Review comments

Example of a control volume

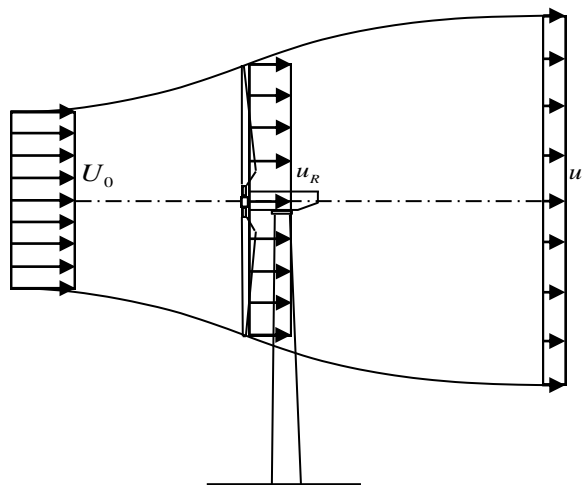
Now, dividing the flow domain into two parts, one going from far upstream of the rotor to a section ending just in front of the rotor and another starting just behind the rotor and ending far downstream, both laterally limited by the stream-surface going through the rotor tips. Using the same notation as in the paper, we get:

Upstream CV analysis: $-\rho A_0 V_0^2 + \rho A_m V_m^2 = \rho A_m V_m (V_m - V_0) = -p_m^+ A_m$

Downstream CV analysis: $-\rho A_m V_m^2 + \rho A_f V_f^2 = \rho A_m V_m (V_f - V_m) = p_m^- A_m$
